A G E N D A

Architectural Review Board

November 18, 2015

3303 Norman Bridge Road
Extant garage structure at rear of the yard

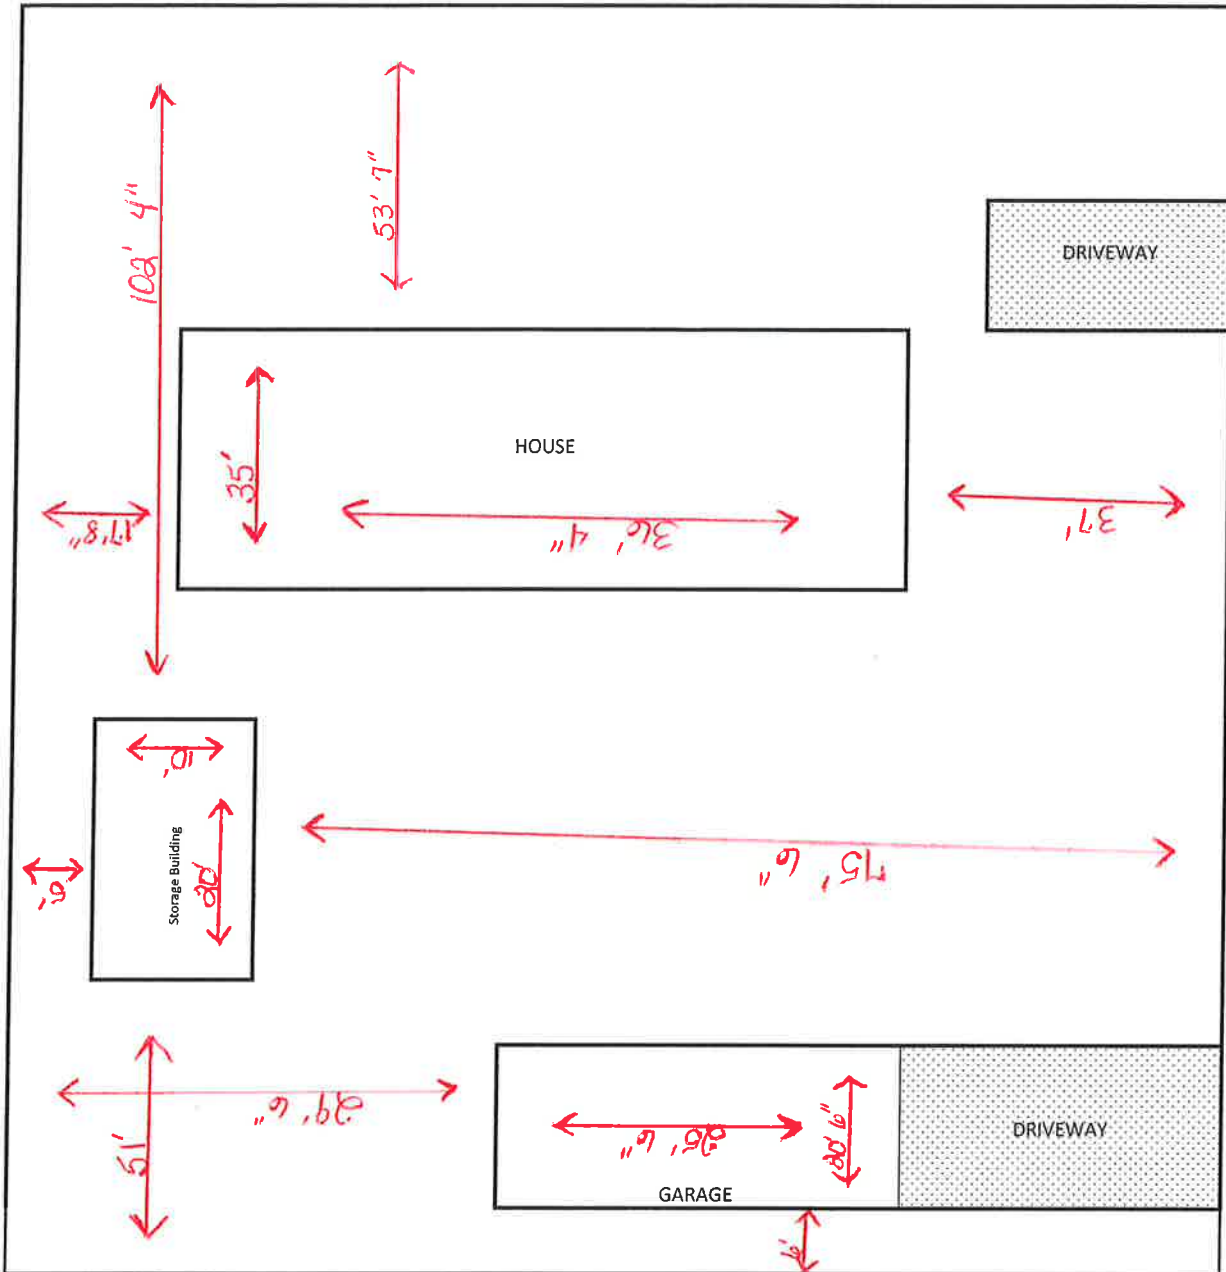
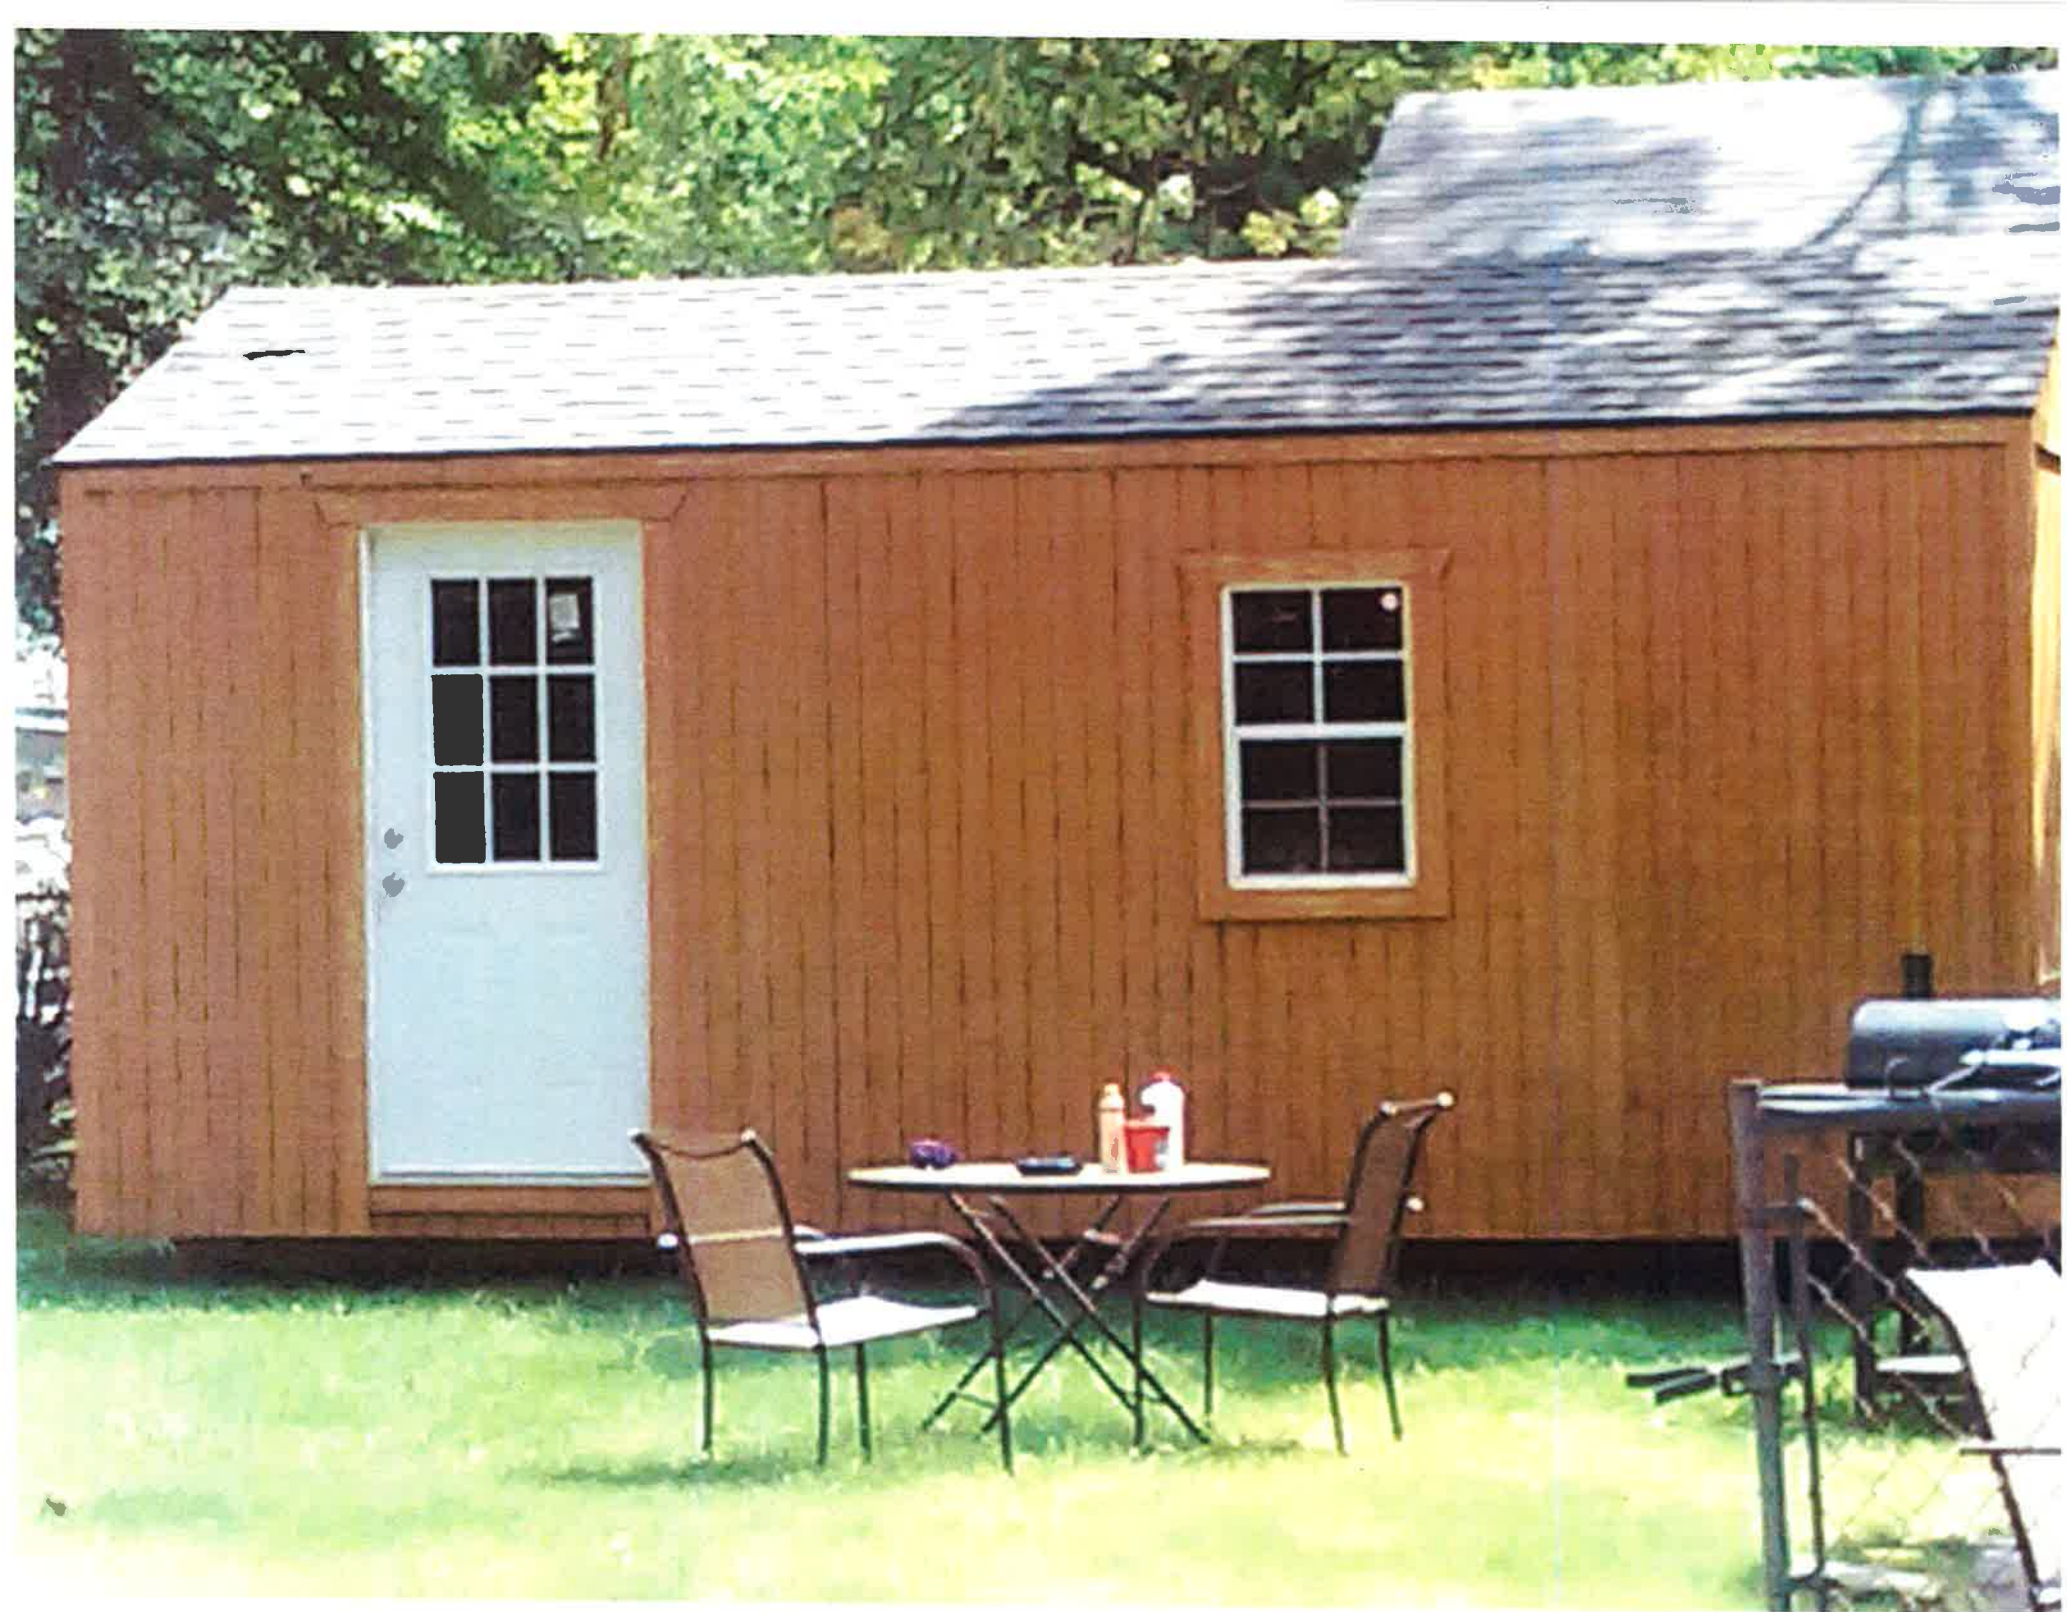
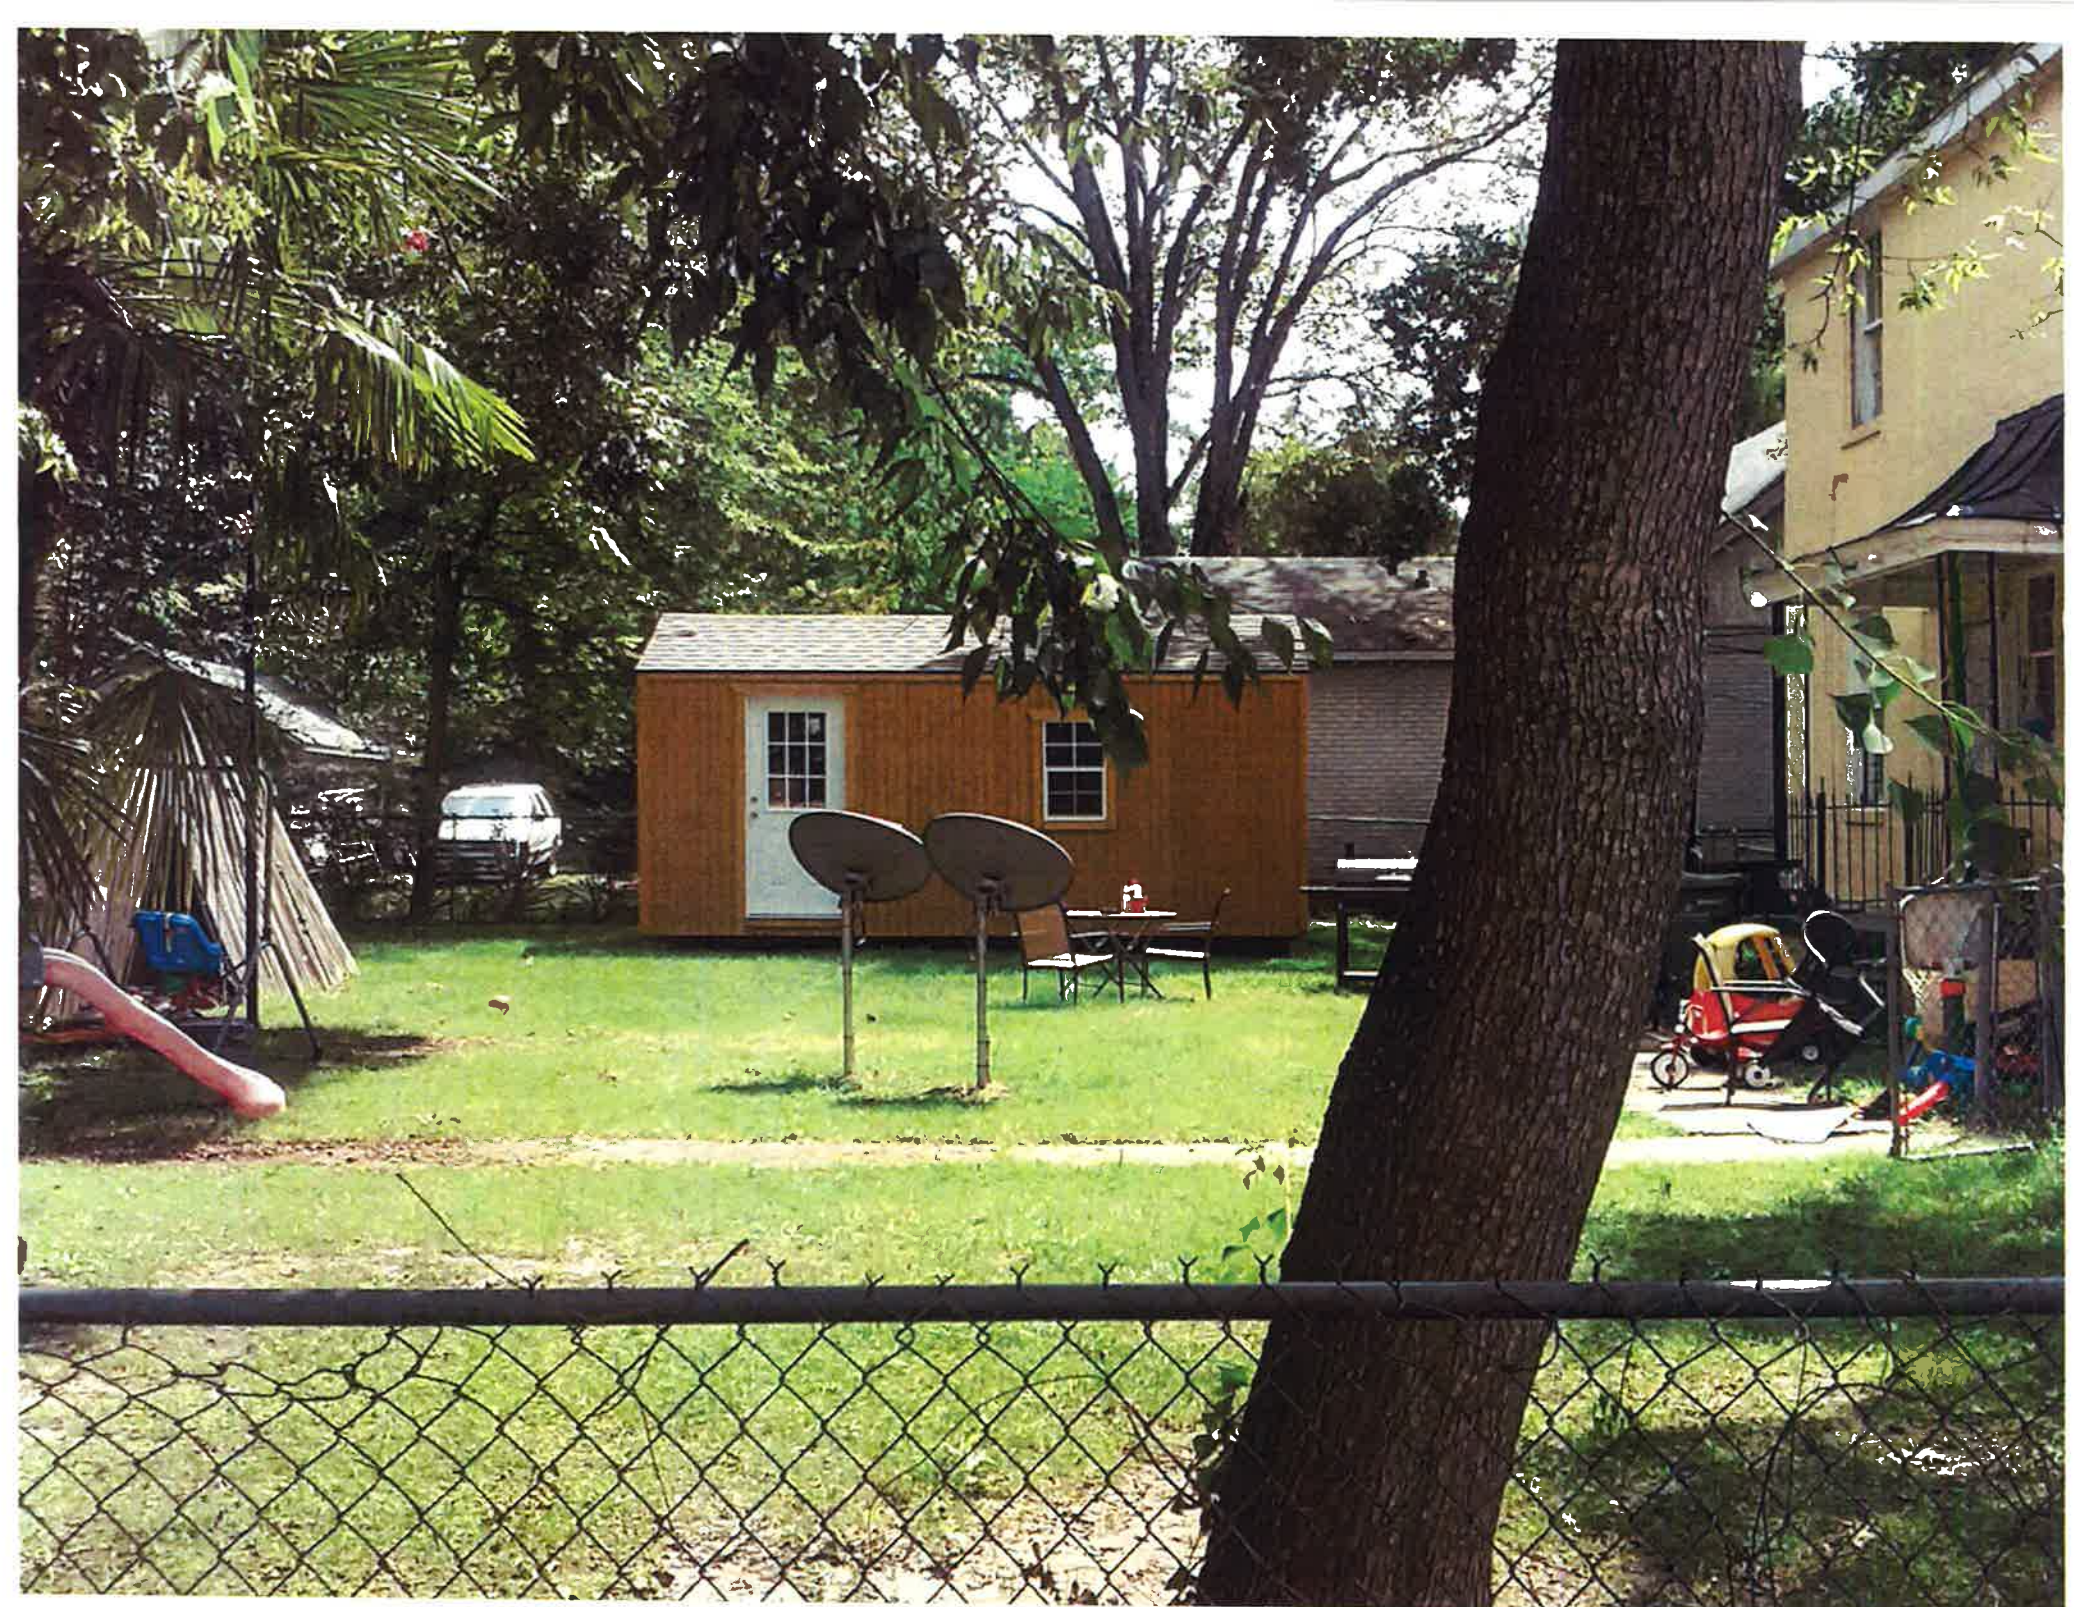
- The Board considers compatibility of new outbuildings with the primary structure, paying particular attention to the eave overhang (that it should have one if the house has one), siding material should be a lap siding (wood or cementitious have been approved) and not a vertical groove panel, and door and window materials should not be vinyl with between the glass lite configurations.
- *Not visible in the original photos and difficult to photograph from the street is that the east gable end is comprised of a metal rollup door.*
